**STAFF REPORT**

HEARING DATE: April 9, 2024  
 TO: Mayor & City Council  
 FROM: Linda Ritter, Associate Planner  
 208-884-5533  
 SUBJECT: Keep West Subdivision – AZ, PP  
 H-2023-0047  
 LOCATION: 2625 E. Lake Hazel Rd. and 6519 S. Raap Ranch Ln., in the NE 1/4 of Section 5, T.2N., R.1E. (Parcel # R7317670010 and R7317670020)

Annexation and zoning of 16.25 acres of land from RUT to R-2 (low "density residential") zoning district and a Preliminary Plat consisting of 22 buildable lots, one existing home and 8 common lots on 15.76 acres of land in the R-2 zoning district for Keep West Subdivision.

C. Preliminary Plat (dated: 2/15/24)

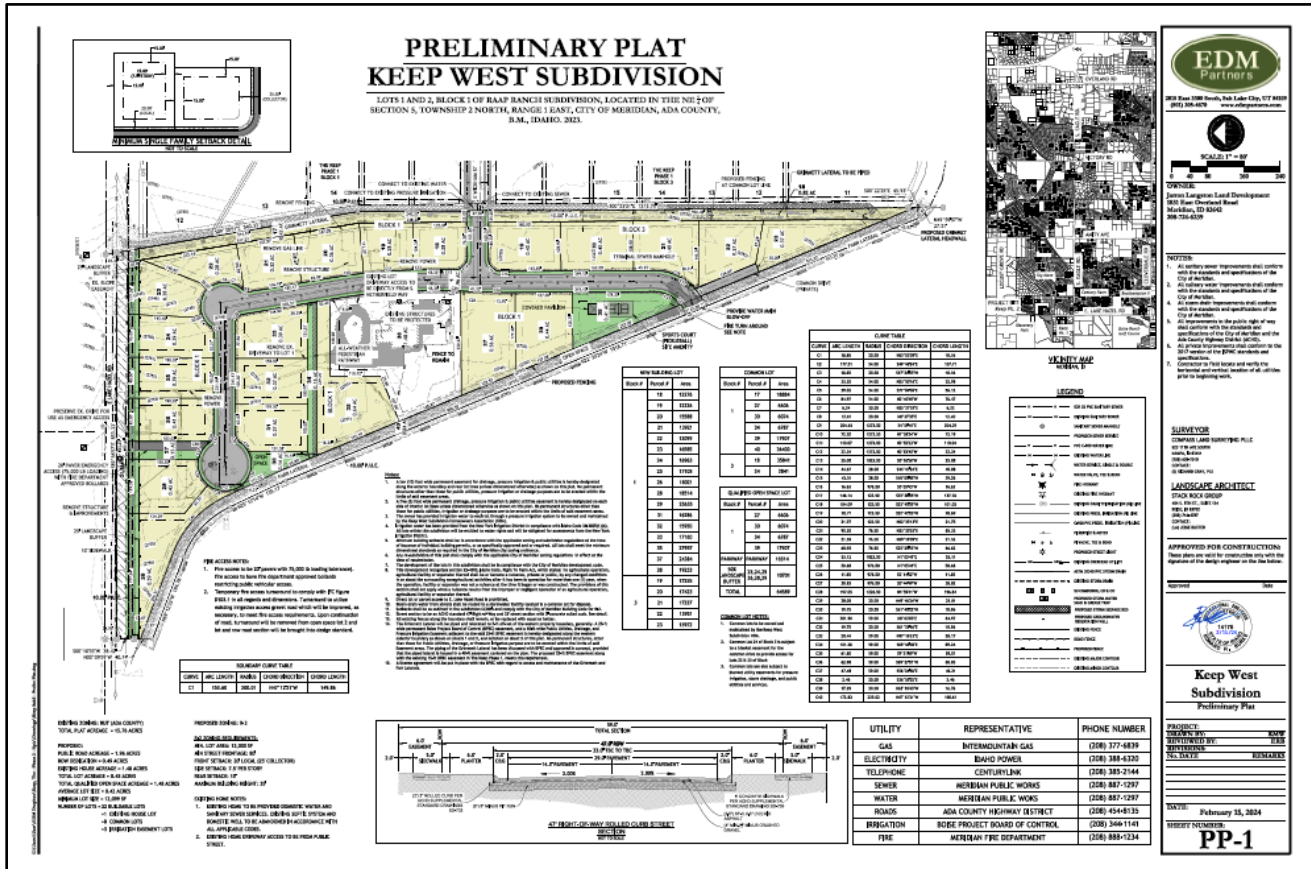
***The cul-de-sac for the proposed plat is greater than 900 feet which would exceed the maximum approval allowed by City Council of 750 feet in length. The applicant needs to revise the plat map shortening the length of the cul-de-sac and submit a revised plat map fifteen days prior to the City Council meeting.***

- a. Bring the proposed cul-de-sac into compliance prior to the City Council hearing.

7. **The applicant shall submit a revised plat map, fifteen days prior to the City Council meeting, showing the cul-de-sac does not exceed the required 750 feet in length.**

D. Common Driveway Exhibit (dated: 2/15/24)

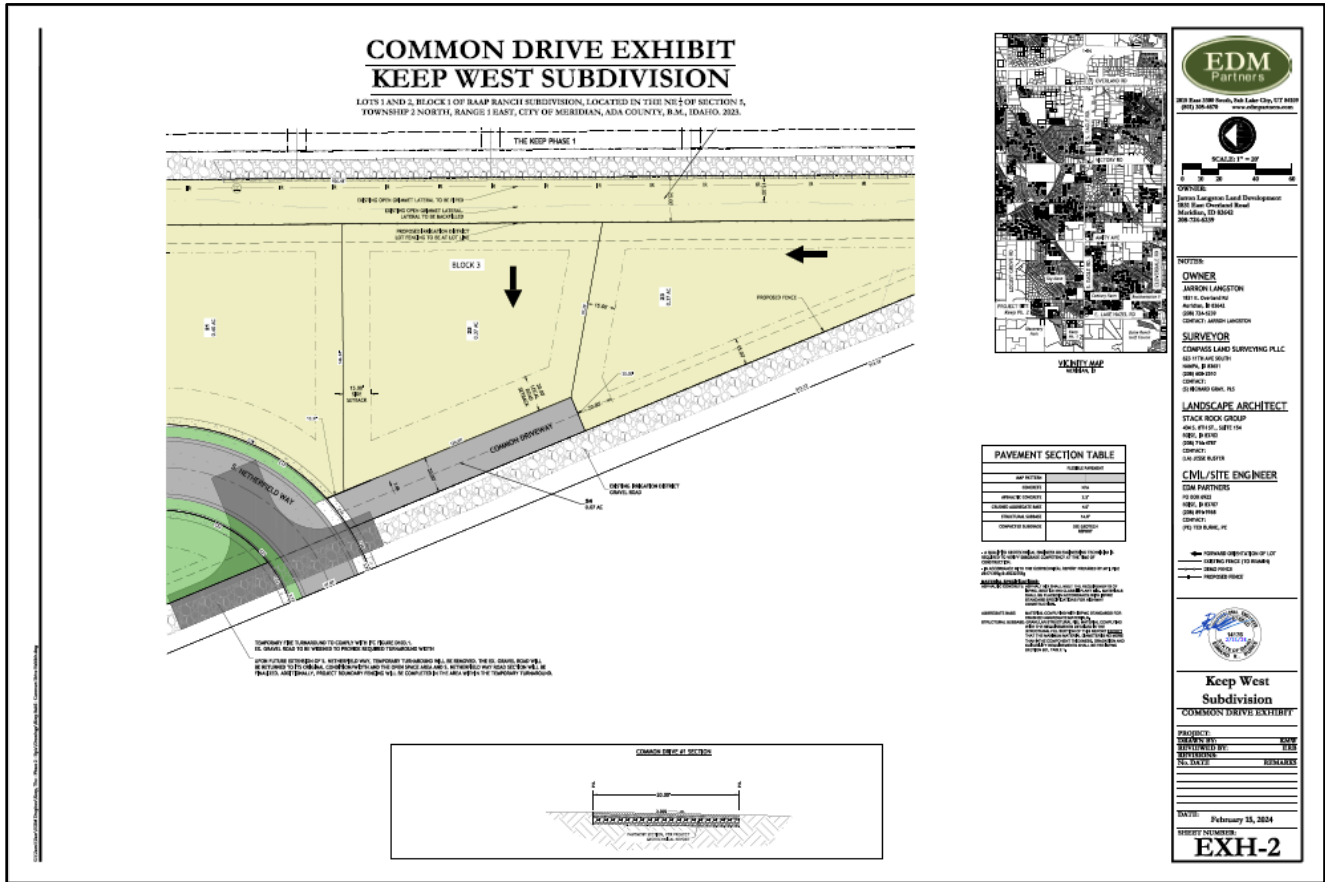
4. The common driveway for Lot 22 and 23, Block 3 shall comply with the standards listed in UDC 11-6C-3D and the exhibit in Section VIII.C.
  5. The address of the existing home shall change with development of the subdivision.

E. Landscape Plan (dated: 1/9/2024)

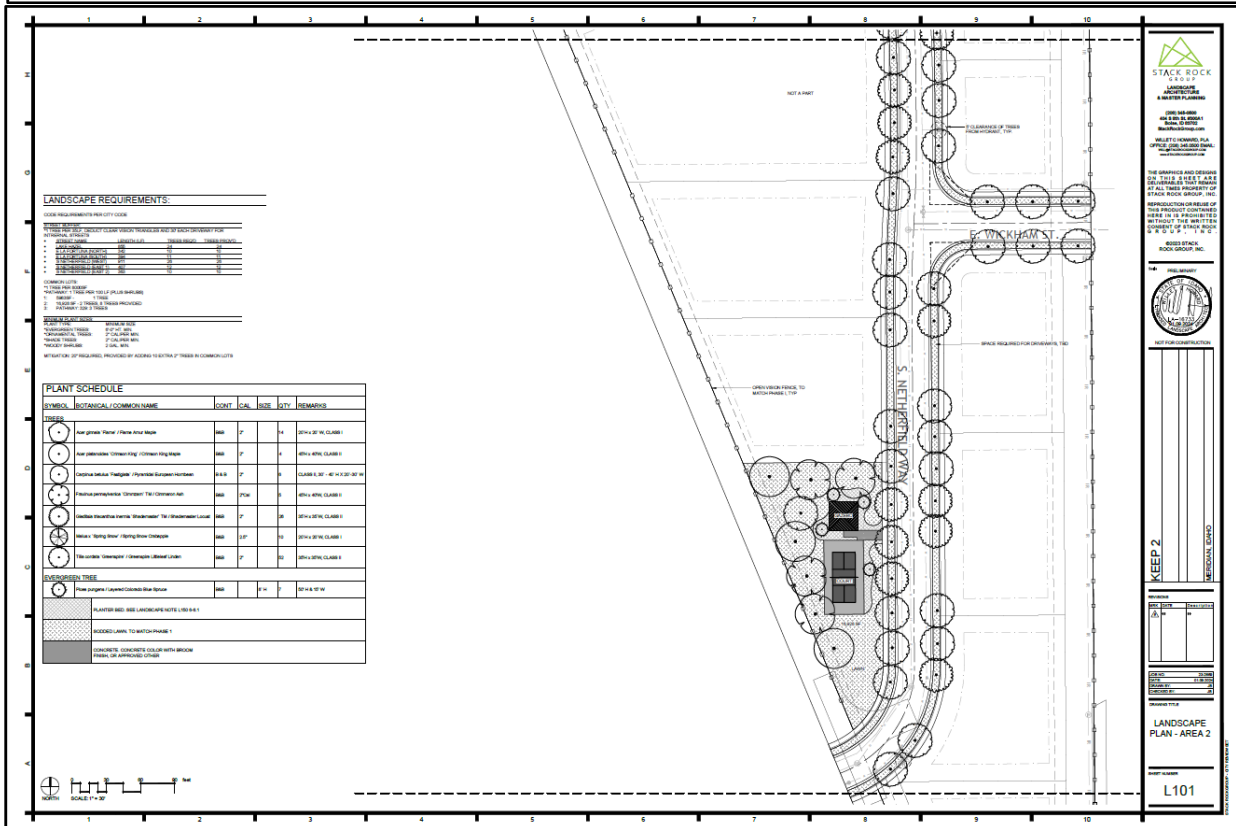
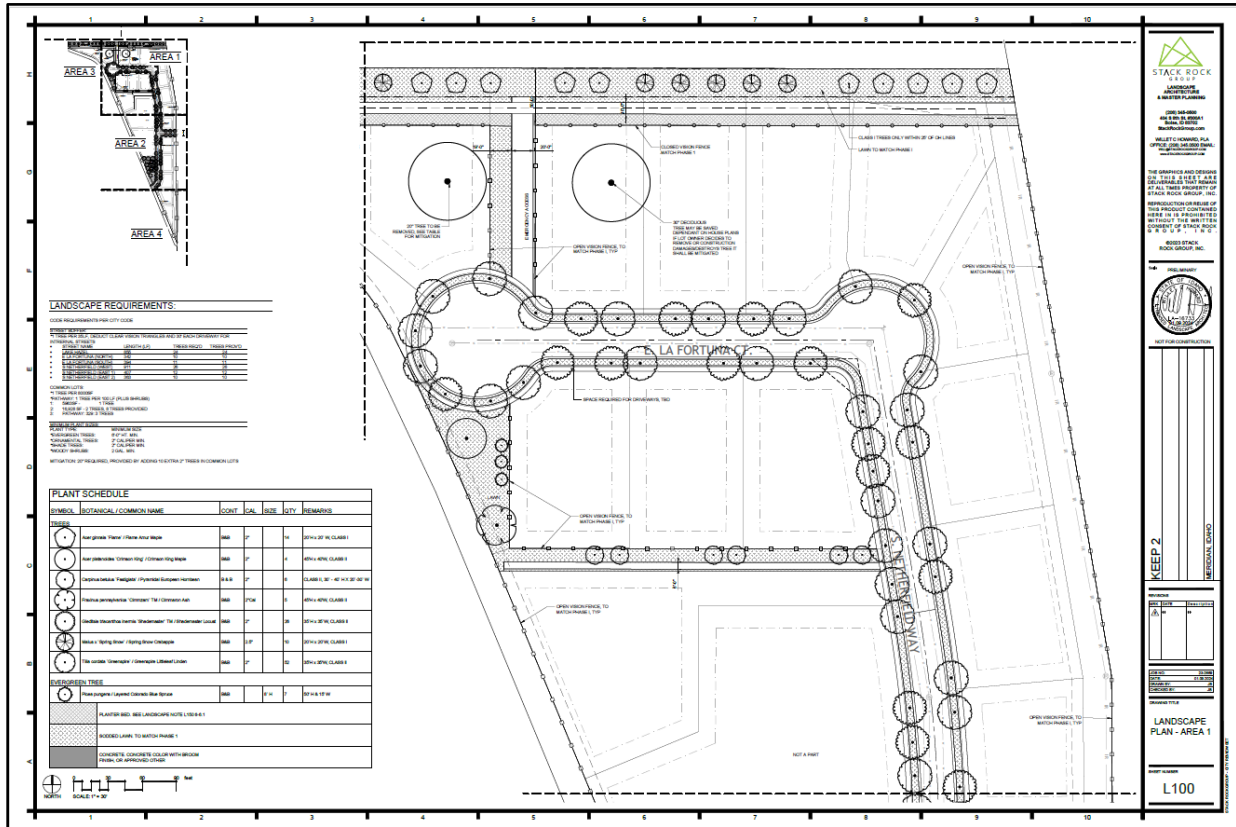
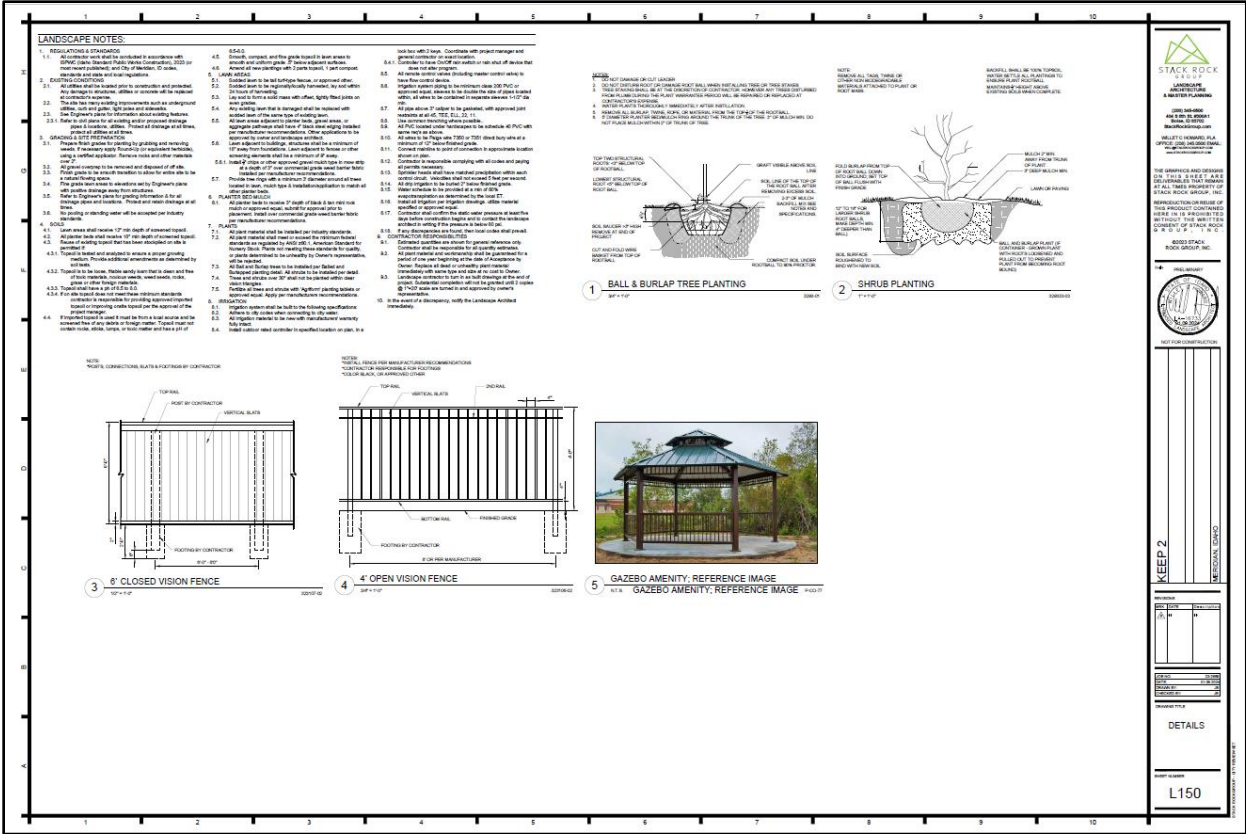
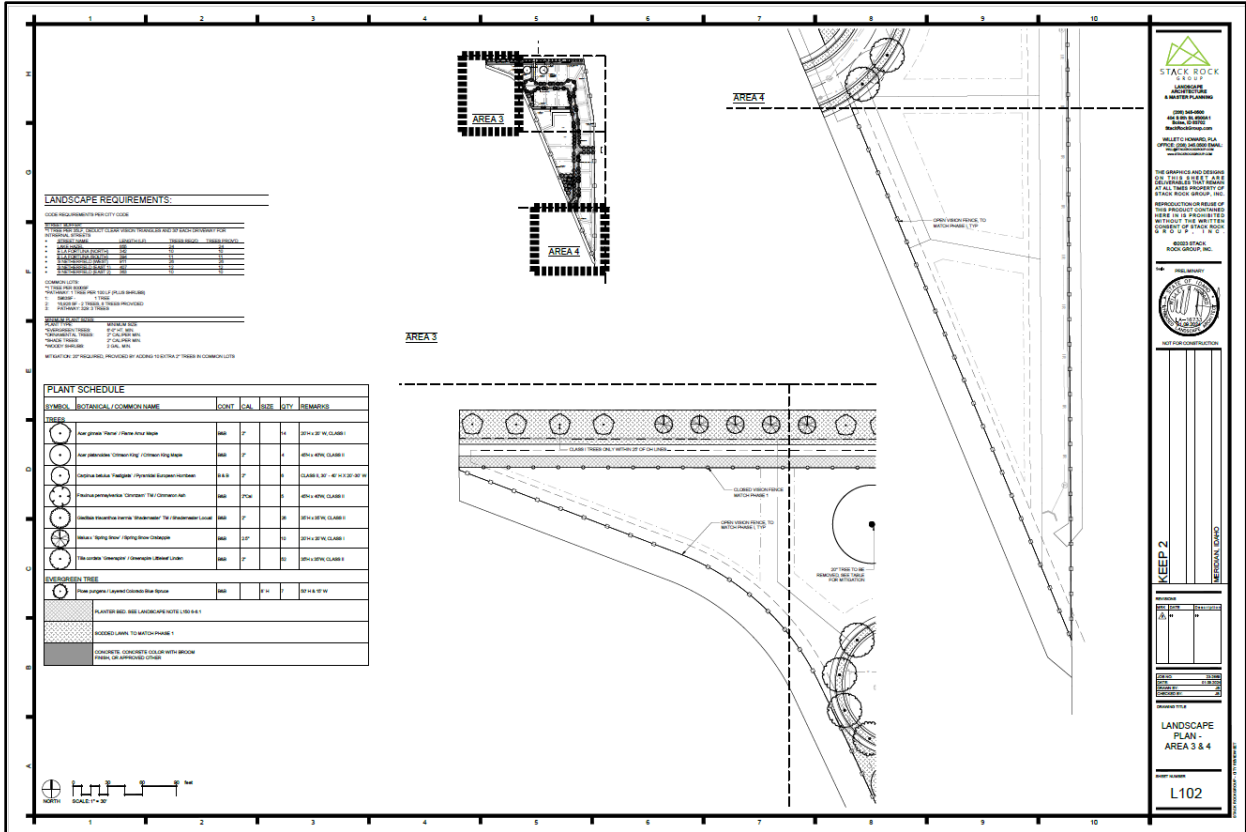
**There are several existing trees on the site, where possible existing trees should be retained. Mitigation is required in accord with the standards listed in UDC [11-3B-10C.5](#); calculations demonstrating compliance with the aforementioned standards should be depicted on the landscape plan.**

3. The landscape plan submitted with the final plat shall include the following revisions:
    - a. Include mitigation information for all existing trees being removed from the site in accord with the standards listed in UDC 11-3B-10C.5.

- b. Provide landscaping along both sides of the pathway per UDC 11-3B-12.C
    - c. Extend the pathway on Lot 34, Block 1 to the cul-de-sac instead of having it dead end at Lot 40, Block 1.
